FINAL CHANGE OF USE – WORK PLAN

**RER ENERGY GROUP, LLC
TOWN OF DEWITT LANDFILL
2.6MW SOLAR PV ARRAY
TOWN OF DEWITT, ONONDAGA COUNTY, NEW YORK**

**CHANGE OF USE – WORK PLAN
RER ENERGY GROUP, LLC
TOWN OF DEWITT LANDFILL 2.6MW SOLAR PV ARRAY
TOWN OF DEWITT, ONONDAGA COUNTY, NEW YORK**

**Subject: Dewitt Landfill, Site #734012
Change of Use- Work Plan; March 2019
Village of Dewitt, Onondaga County**

Test No. 1- Load vs. Settlement Curve

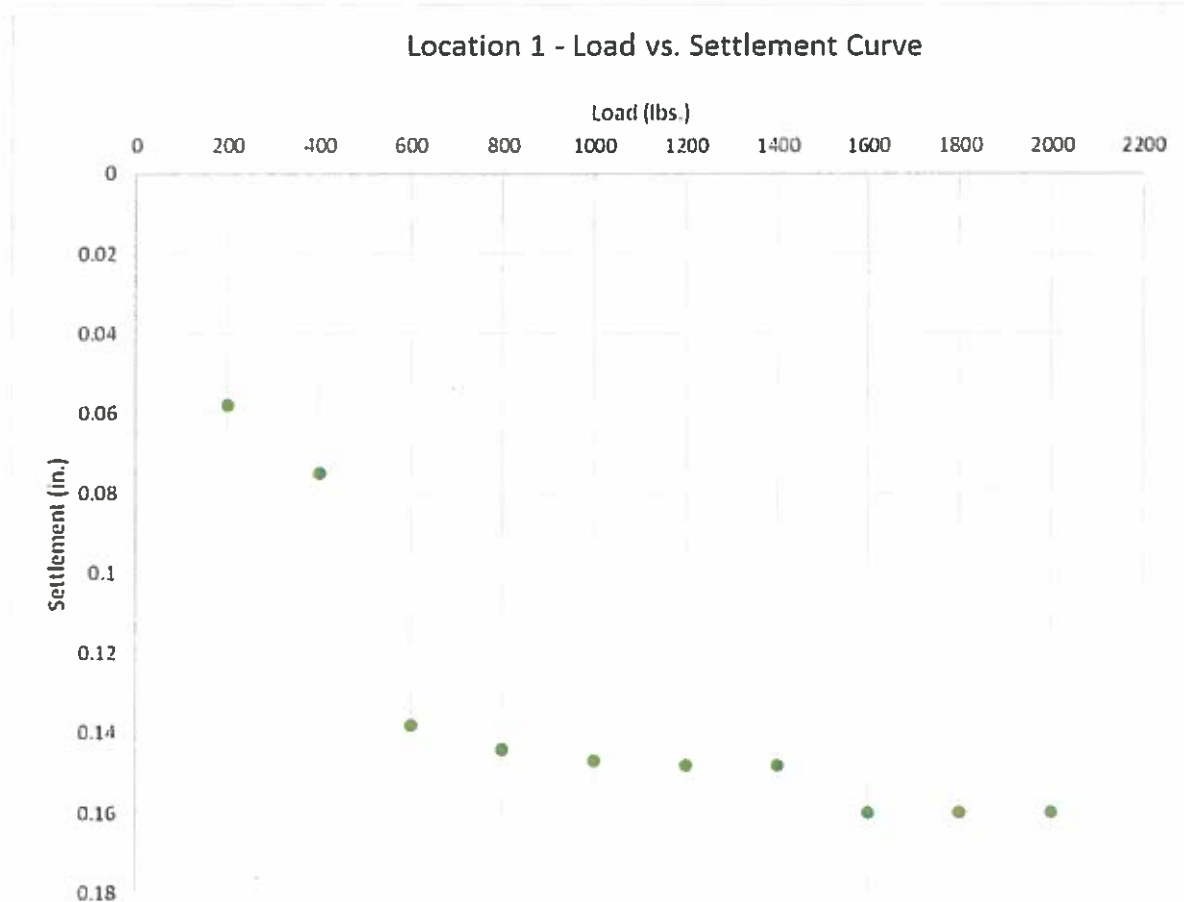
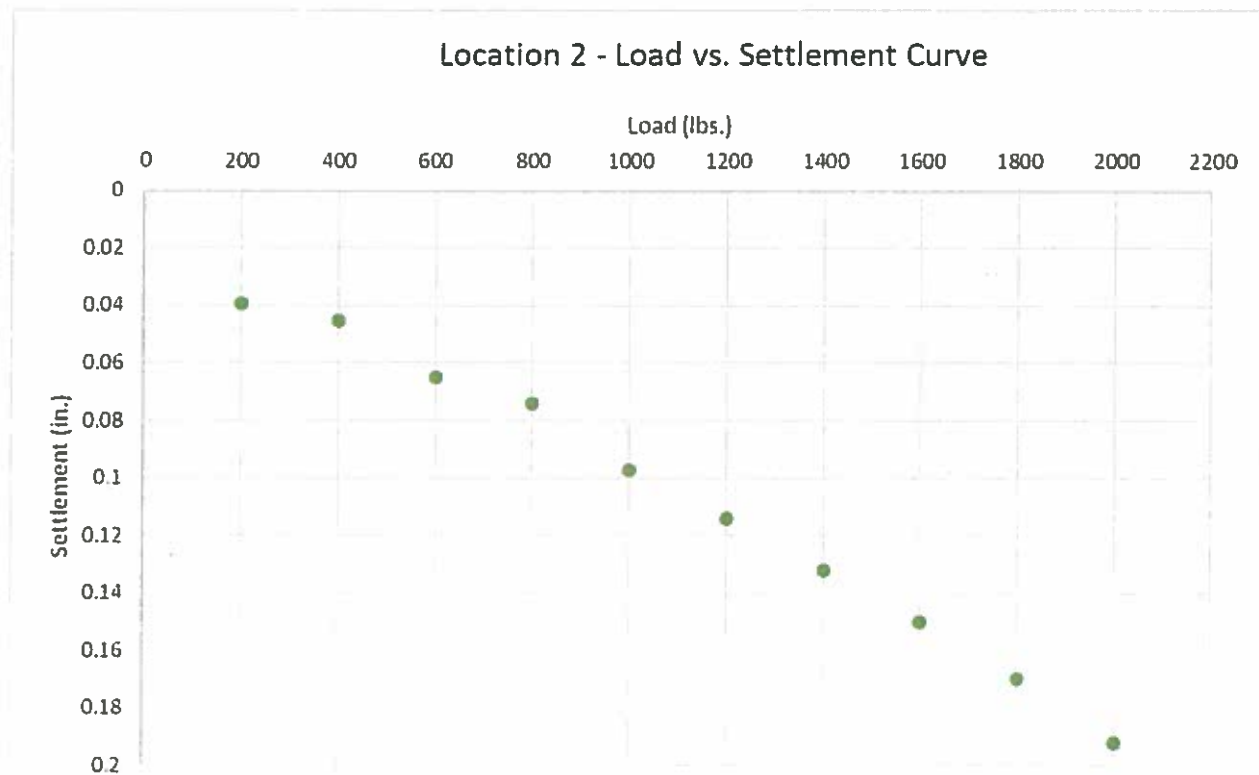
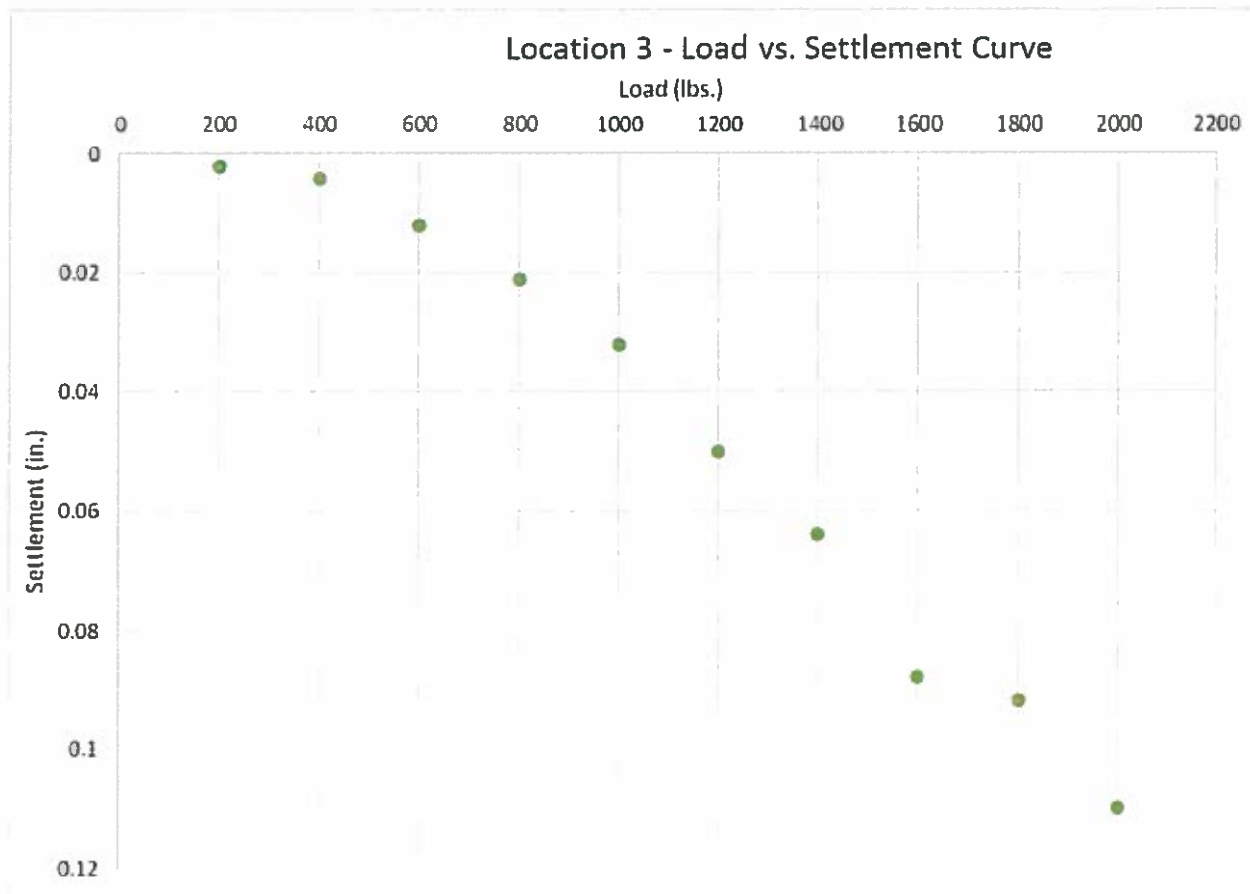
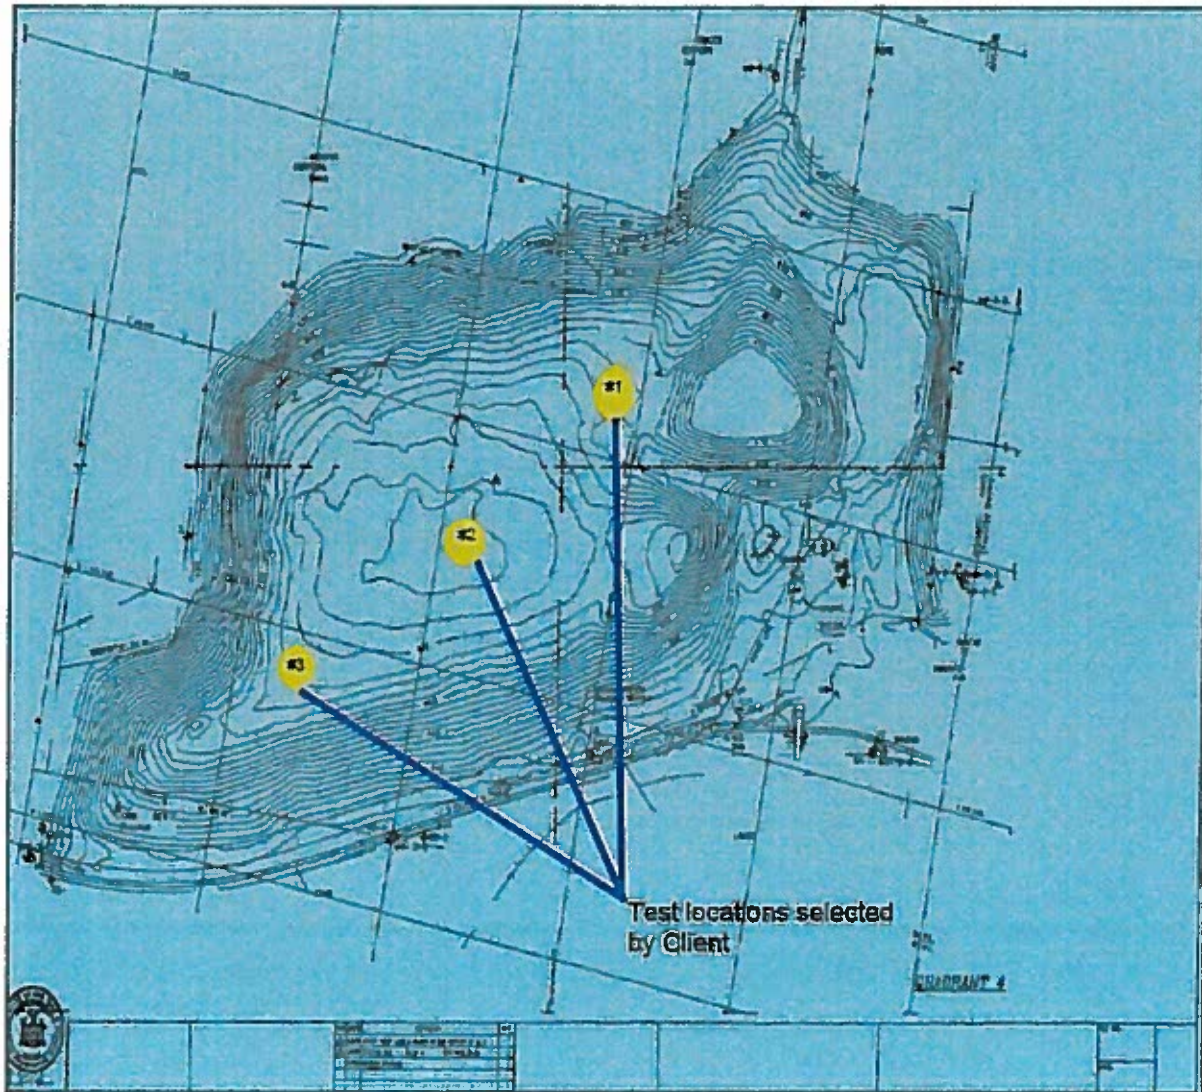
DEC Request: Section 3.0, Geotechnical Investigation of the Work Plan (WP) requires further discussion of the tests performed and an evaluation as to whether the engineered cap system will support the proposed infrastructure. Define "minimal" as used in the 7th sentence. This section must include a statement as to whether the test was performed in accordance with the ASTM standard, must discuss any deviations from the standard, and state whether the test results are usable given any deviations. Test No. 1 indicated water entered the testing area. Test No. 2 and Test No. 3 graphs indicate that settling was continuing to occur at these locations at the completion of the test. The WP must include a settling assessment which discusses the potential for future settling and the impacts which may occur.

3. Section 3.0, Geotechnical Investigation of the Work Plan (WP) requires further discussion of the tests performed and an evaluation as to whether the engineered cap system will support the proposed infrastructure. Define “minimal” as used in the 7th sentence. This section must include a statement as to whether the test was performed in accordance with the ASTM standard, must discuss any deviations from the standard, and state whether the test results are usable given any deviations. Test No. 1 indicated water entered the testing area. Test No. 2 and Test No. 3 graphs indicate that settling was continuing to occur at these locations at the completion of the test. The WP must include a settling assessment which discusses the potential for future settling and the impacts which may occur.

C&S Response: CME Associates, Inc. (CME) conducted limited geotechnical work at the project site. Static load testing was performed below topsoil at three locations in general conformance with ASTM D1194-94 "Standard Test Method for Bearing Capacity of Soil for Static Load and Spread Footings" with the following exceptions:

- 1.) A 20-ton jack assembly was used in lieu of the 50-ton jack assembly specified in the referenced ASTM standard, Section 3.2 According to CME Associates, the 20-ton jack assembly used was more than sufficient for the relatively small test load (1 – ton).
- 2.) The reference beam utilized was 8-feet total length, and therefore was supported at lengths of 4-feet from the center of the loaded area. The referenced ASTM standard, Section 4.5 calls for reference beam supports at 8-feet from the center. According to CME, the change does not adversely affect the test readings due to the relatively small test load being used.
- 3.) The test method calls for the load to be decreased incrementally so that rebound can be measured. However, due to the utilization of a hydraulic ram and jack, the test load could not be incrementally reduced and therefore, no rebound measurements could be made.
